MARSHA A. BURCH
LAW OFFICE

**Re: Appeal of Planning Commission Approval of AG Forest Wood Processing
Bioenergy Facility Major Use Permit UP 23-05, Initial Study/Mitigated
Negative Declaration IS 23-10**

Dale La Forest & Associates
Environmental Design & Planning
101 E. Alma Street, Suite 100-A
Mt. Shasta, California 96067
dlaforest@gmail.com
Phone: (530) 918-8625

FIGURE B - DISTANCES FROM NOISE SENSITIVE RECEPTORS TO CONSTRUCTION NOISE

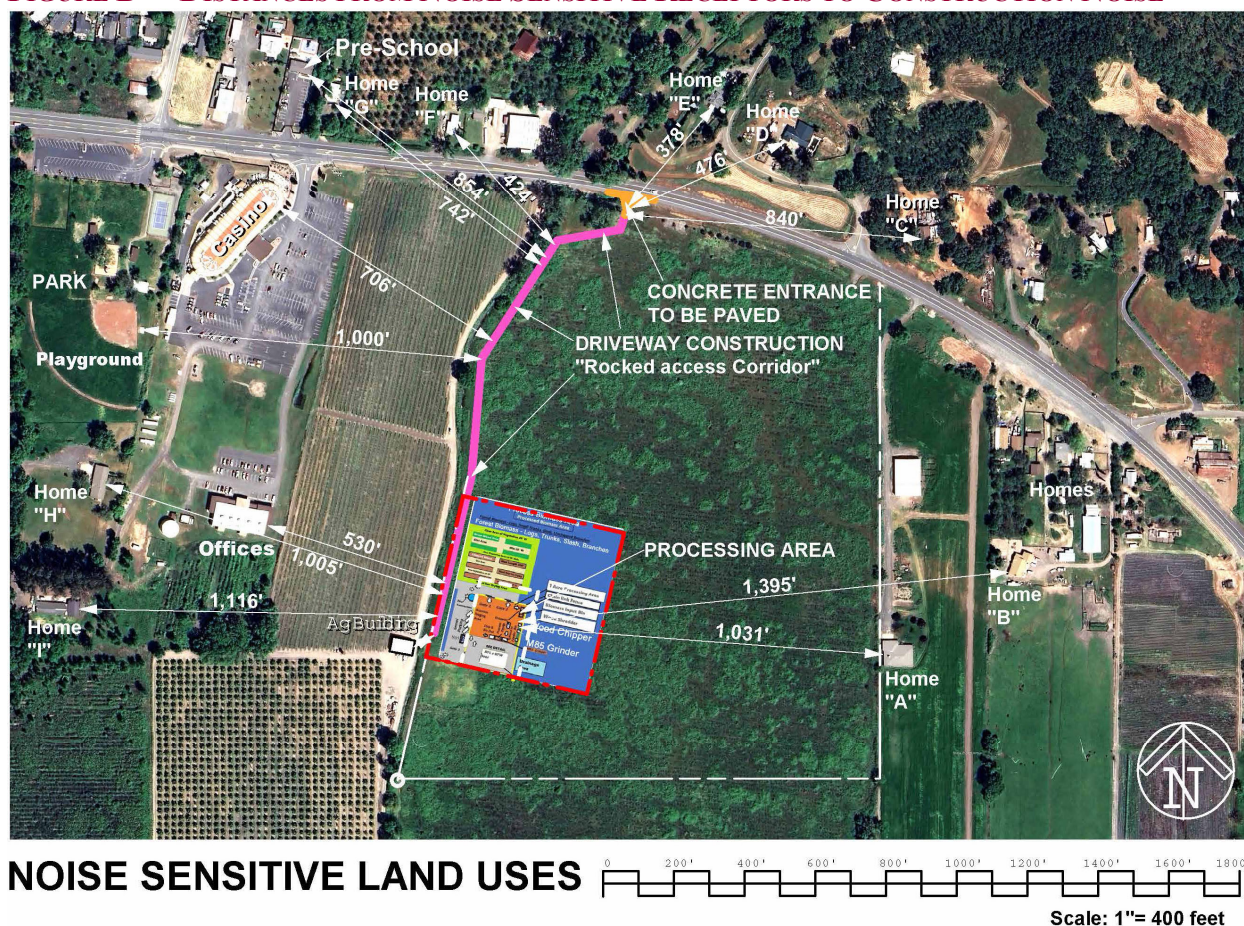
DRIVEWAY CONSTRUCTION COULD GENERATE NOISE LEVELS INSIDE SOME NEIGHBORING HOMES THAT EXCEED THE COUNTY'S GENERAL PLAN 45 dBA CNEL INTERIOR NOISE LIMIT.

With an exterior noise level of 71.6 dBA CNEL at Homes "H" and "I's windows, and with a typical attenuation (reduction) factor of 20 dBA due to noise passing through the walls and roof of a home with its windows closed, the interior noise level indoors would be as much **51.6 dBA CNEL**.¹⁹ That interior noise level due to Project construction would exceed the Building Code standards and the County General Plan's maximum allowable **45 dBA CNEL** interior noise limit. Even with a slight reduction in noise levels due to atmospheric attenuation of about 1 dB at these distances, the interior noise levels would still exceed the County's maximum standards. Therefore this Project's construction noise impacts to the interior noise levels would be significant at some homes.

FIGURE C - DISTANCES FROM NOISE SENSITIVE RECEPTORS TO WOOD CHIPPER NOISE

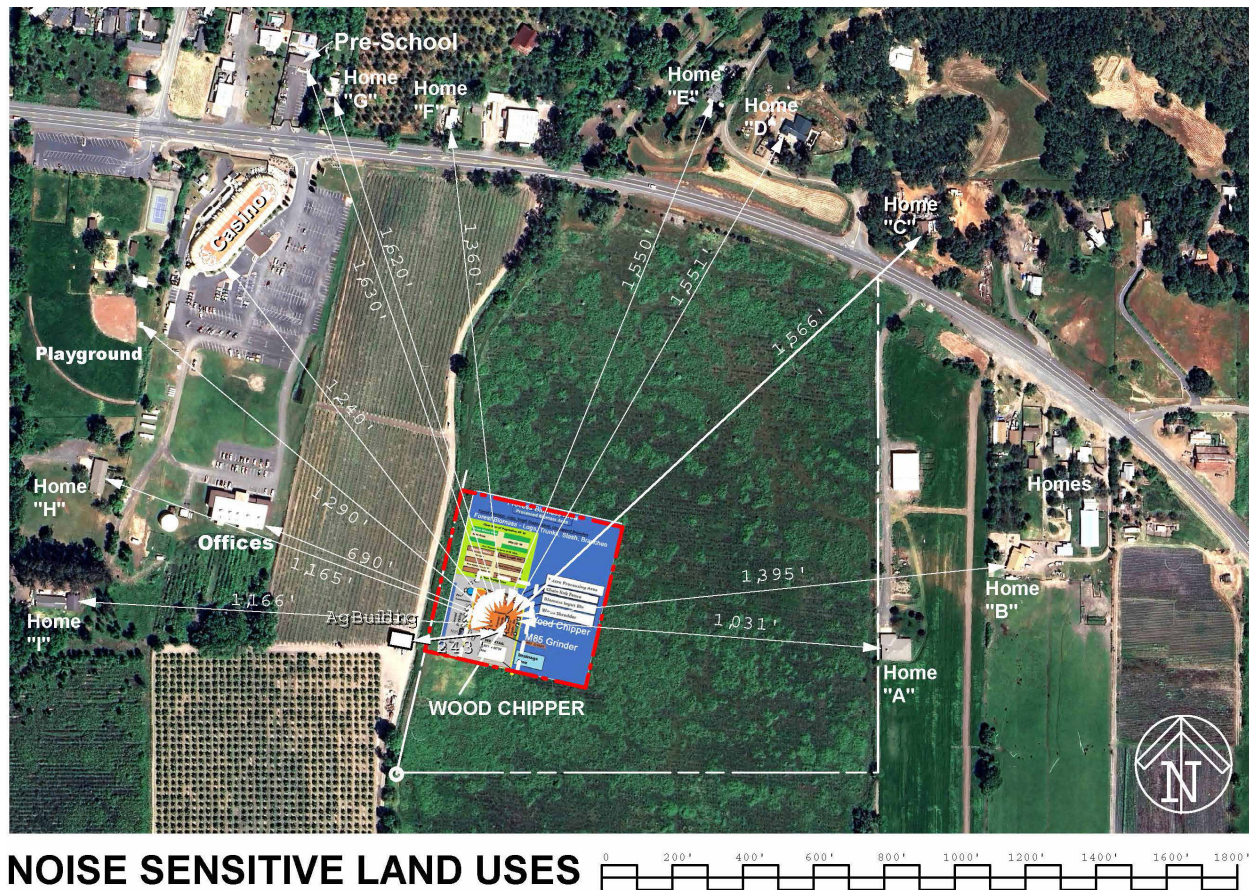
⁴⁹ See Figure C for that distance of 1,290 feet from the Project's central processing area with the chipper to the Park.

FIGURE A - DISTANCES FROM PROJECT OPERATION TO NOISE SENSITIVE RECEPTORS

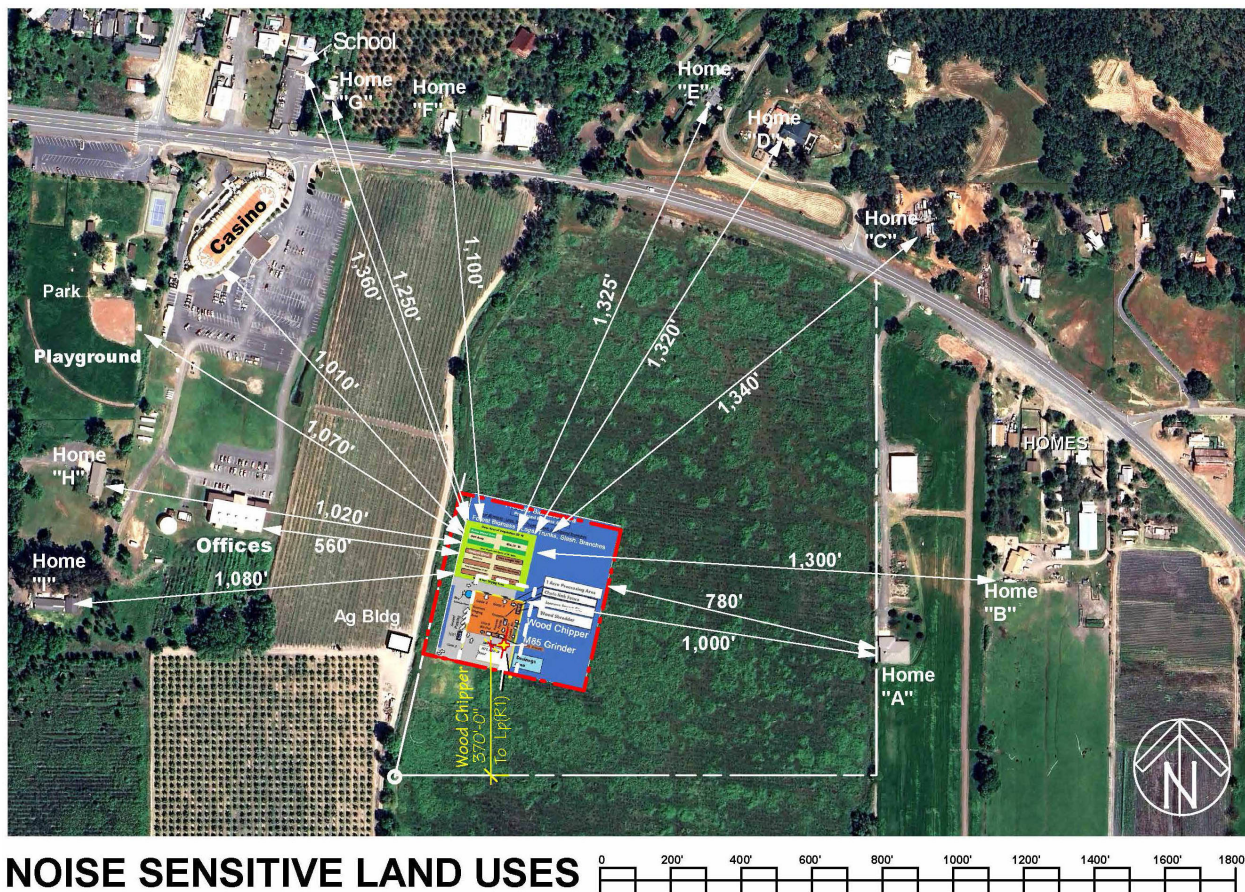
- F. **Operation noise** levels may exceed the County's noise standards at the office building with tribal offices located about 690 feet to the west of major Project noise sources. At that close distance, the noise level from Project operations would cause a significant noise impact. Yet the IS/MND never analyzed that serious risk to those office users that could harm their business work and personal health. (See p. 32 and Figure A.)

- G. **Operation noise** levels at the Running Creek Casino located about 1,010 feet to the northwest of major Project noise sources may also exceed the County's noise standards for commercial uses. (See p. 33 and Figure A.) The Zoning Ordinance allows up to 60 dBA $L_{eq-1\text{ hr}}$, but Project operation noise at the casino could be as high as about 68.2 dBA $L_{eq-1\text{ hr}}$. (See p. 33.)

The nearest homes to the north of the Project’s chip yard are located between 1,100 to 1,340 feet away from where backup alarms would be used while workers load chips into outdoor storage piles. (See Figure A, Map of “Noise Sensitive Land Uses” on page 6 of this Report for location of Homes "C", "D", “E”, “F”, and “G”). These distances are estimated using Google Earth's measuring tool and computerized drafting software.
